Hydrol. Earth Syst. Sci. Discuss., 9, C2175–C2178, 2012

“Hydrogeological characterisation of a glacially affected barrier island – the North Frisian Island of Föhr” by T. Burschil et al.

Author Comment to Referee #2 by Thomas Burschil et al.

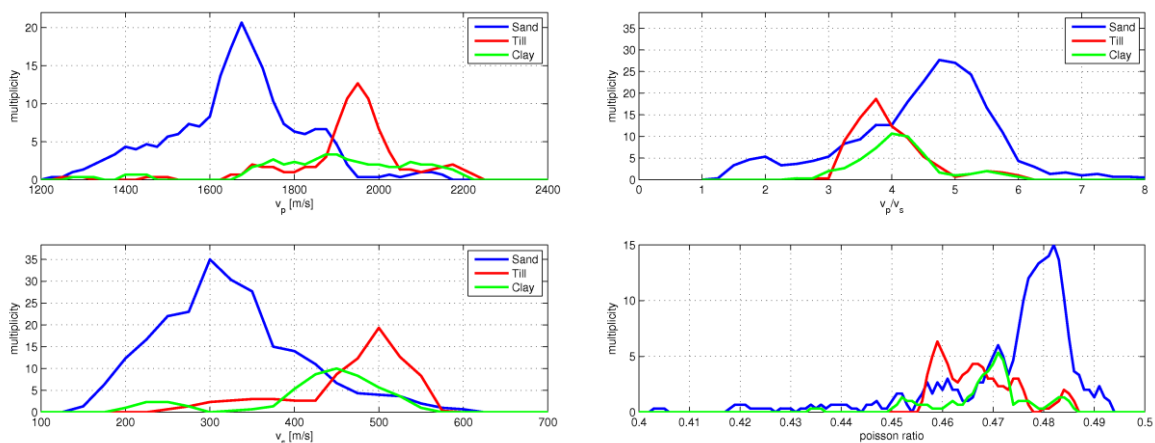
RC: Section 3.4 and 3.5: Combined analysis and 3-D model should be much more explanatory, how are the data exactly used to build or improve the model, what part of the data is incorporated into the model? How is dealt with small scale bodies or uncertainties?

AC: *We will extent these chapters and improve clearness through new figures.*

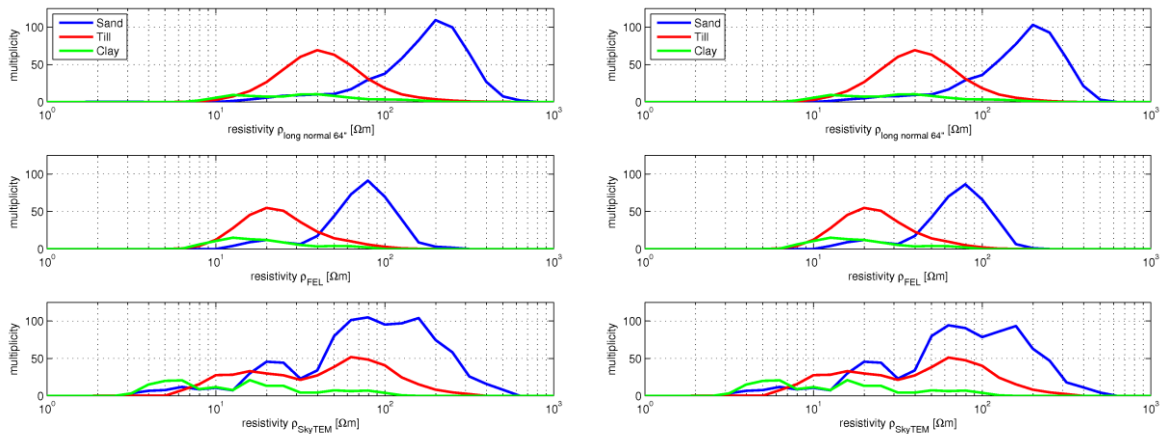
RC: What happens to the petrophysical relationships with different water content (if layers bear more or less water, fluctuating groundwater table)?

AC: *The groundwater table fluctuates in a range of 0.2 m to 0.9 m annually [Hydrogeologisches Gutachten]. Since we are using only deep boreholes with a maximum depth of at least 75 m, near surface effects from dry material (first 10 m) can be neglected. We add here a plot with statistics without the first 10 m, where we can expect dry material from the groundwater table measurements. There are no significant changes between the plot with all values (left panel) and the plot without the first 10 m (right panel).*
